THE VILLAGE SUBDIVISION

P.O.A.D.P.

Re: The Village Subdivision (Amended)

MDP # 473-B

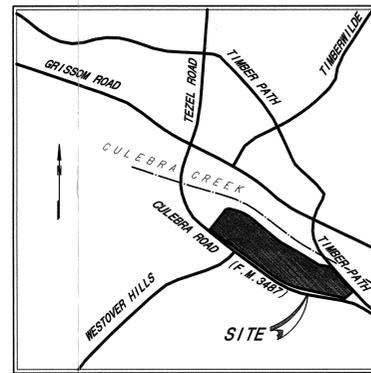
The City Staff Development Review Committee has reviewed The Village Subdivision (Amended) Master Development Plan M.D.P. # 473-B. Please find enclosed a signed copy for your files. Your plan was accepted, however please note the following:

- In consideration of public safety and convenience, excessive grades by reason of topography should be avoided in street layouts and arrangements.
- Any access and R.O.W. issues along state facilities will need to be resolved with the Texas Department of Transportation (TXDOT). For information about these requirements you can contact TXDOT at 615-5814.

- This development will need to comply with tree preservation ordinance #85262. The 1997 Tree Preservation ordinance and Streetscape standards. For information about these requirements you can contact Tree Preservation at 207-70278.

- It will be expected that you will plat all of the property depicted in your Master Development Plan (M.D.P.) to include floodplains, drainage areas and open space.

- I would encourage you to work closely with the school district, so that they can plan accordingly.
- Storm Water Engineering has reviewed the Village 473-B POADP amendment submittal and comments are as follows:

1. This project is eligible for regional storm Water Management Participation (FILO).
